DEPARTMENT OF HAWAIIAN HOME LANDS
STATE OF HAWAII

ADDENDUM NO. 1 TO
PROPOSAL, SPECIFICATIONS, CONTRACT AND BOND FOR
IFB NO.: IFB-12-HHL-001

KAKAINA SUBDIVISION, WAIMANALO

ADDENDUM NO. 1
TO PROPOSAL, SPECIFICATIONS, CONTRACT AND BOND FOR
KAKAINA SUBDIVISION, WAIMANALO, OAHU, HAWAII
TAX MAP KEY: 4-1-08: 10, 81, & 91
IFB-12-HHL-001

PLAN - POALIMA & MEKIA STREET

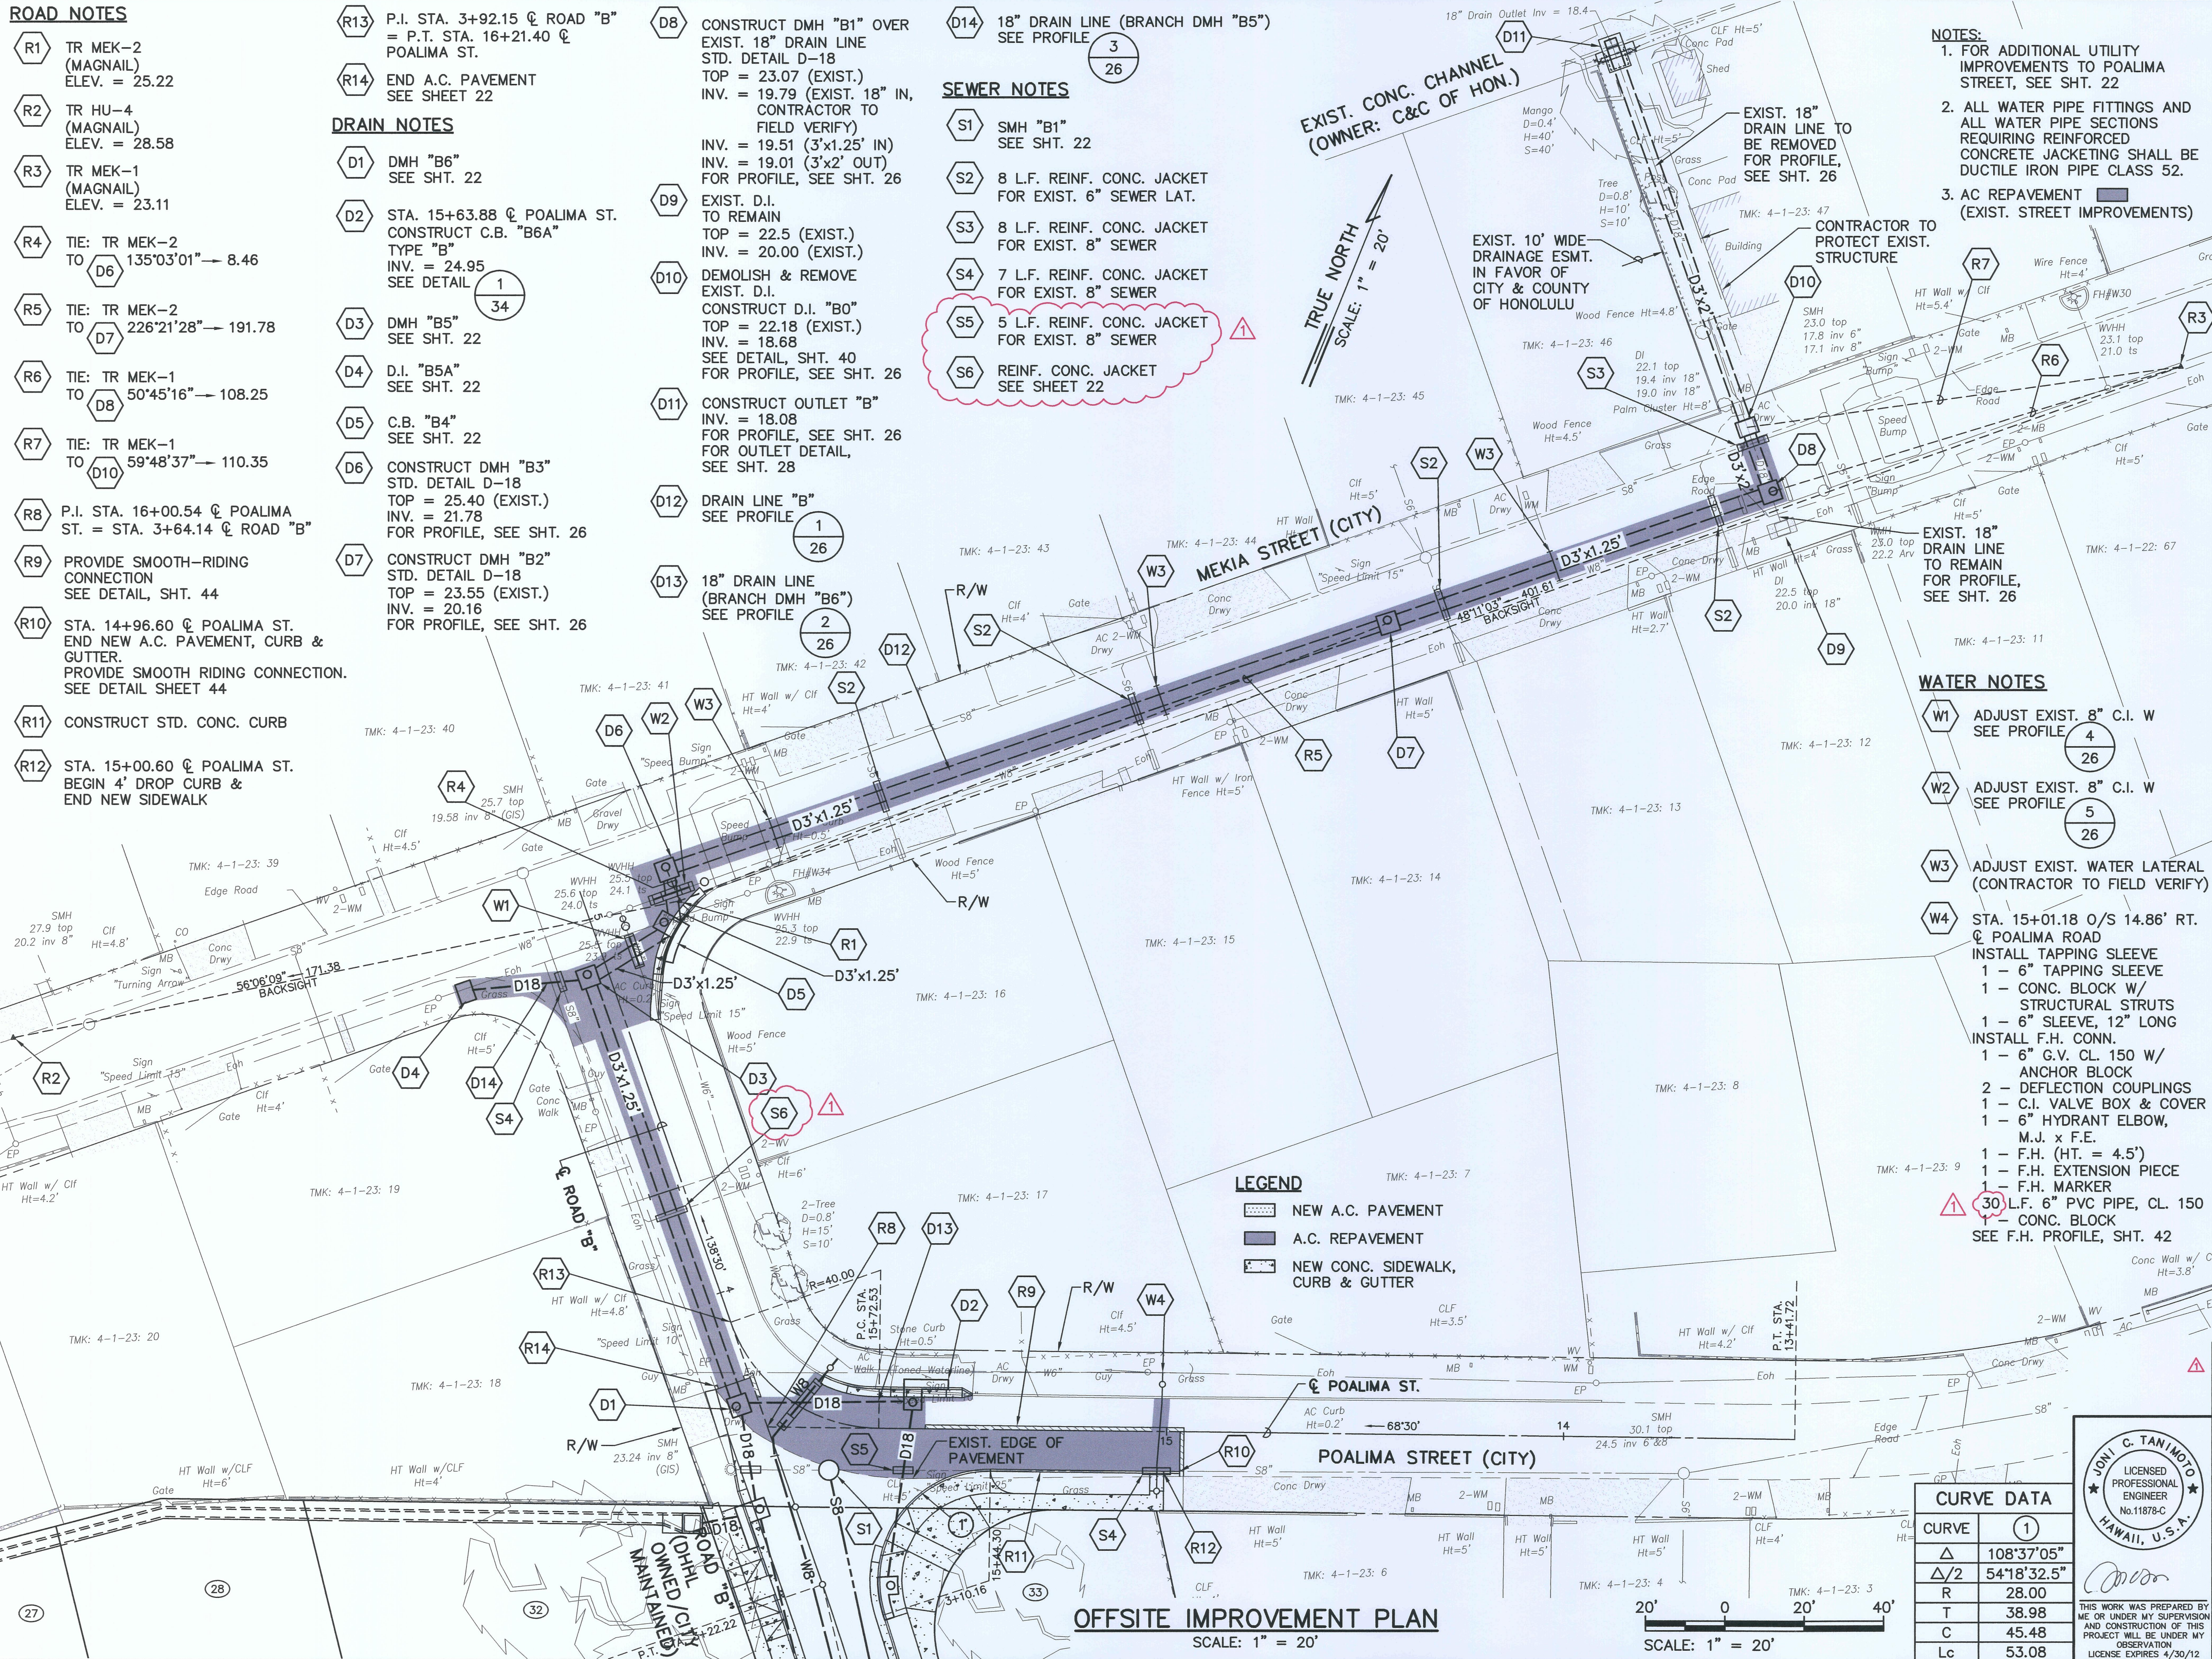
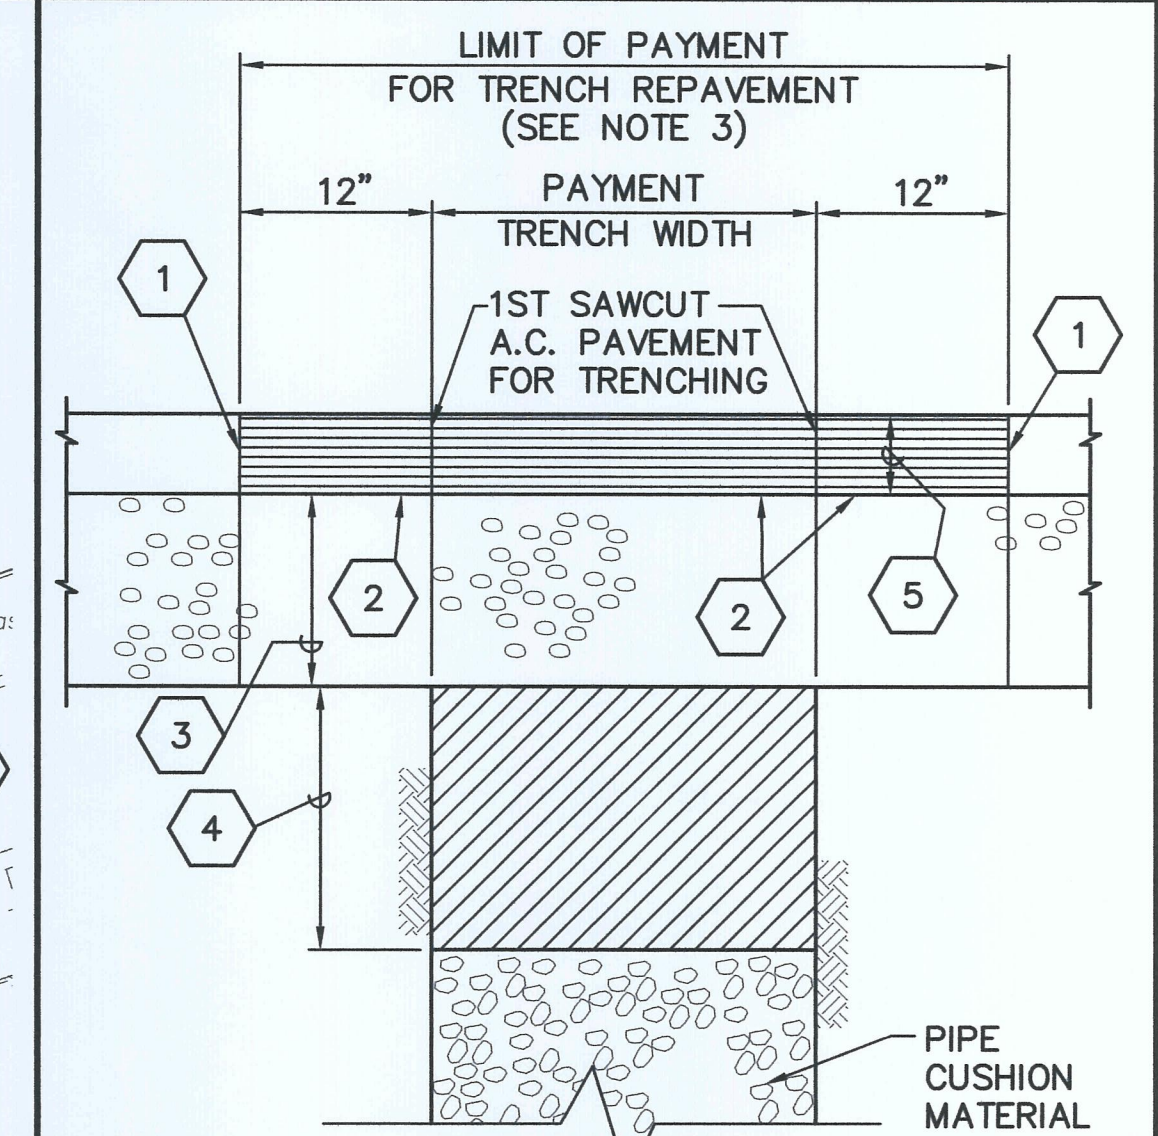
REVISION DATE	DESCRIPTION	MADE BY	APPROVED
2/24/2012	REVISE POALIMA FH & SWR JACKET	A&A
